DAUPHIN COUNTY SUBDIVISION/LAND DEVELOPMENT REVIEW REPORT

Municipality: Upper Paxton Township | Surveyor: Burch Associates | Engineer: Not Provided

Plat Title: Naomi K. King

Project Description: Proposed subdivision and proposed residential dwelling

PRELIMINARY/FINAL SUBDIVISION PLAN
FOR

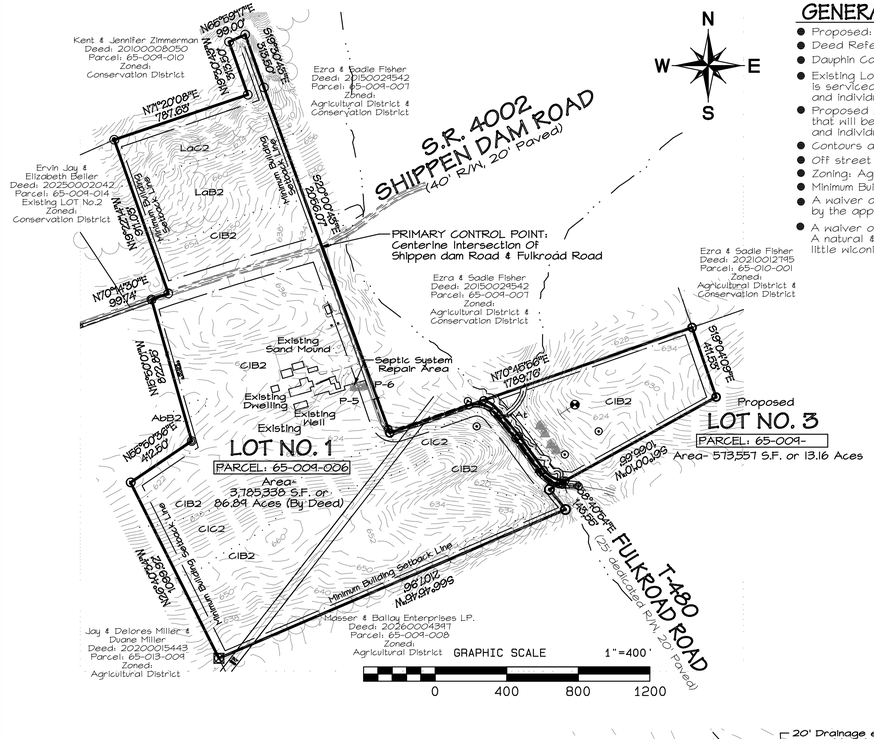
1. All existing watercourses, tree masses and other significant natural features are required to be displayed on the plan. (S-LD § 22-501.A.10 per 22-601.A.1) There appears to be wetlands that are not displayed on the western end of proposed lot 3. The reviewer notes that the Wetlands Note on the plan describes these wetlands, however they should be visually displayed/symbolized on the plan for reference.

3. The lot area of Proposed Lot 3 shall not exceed 10% of the total area of the parcel at the time of initial property subdivision. 13.16 acres equals about 13% of the total area of the parcel (100.14 acres). The plan notes the applicant's intent to request a modification of this requirement.

4. Notes shall be placed on the plan in accordance with ZO § 27-1102.30 (Sections C, E & F) regarding no further subdivision of the existing and proposed lots.
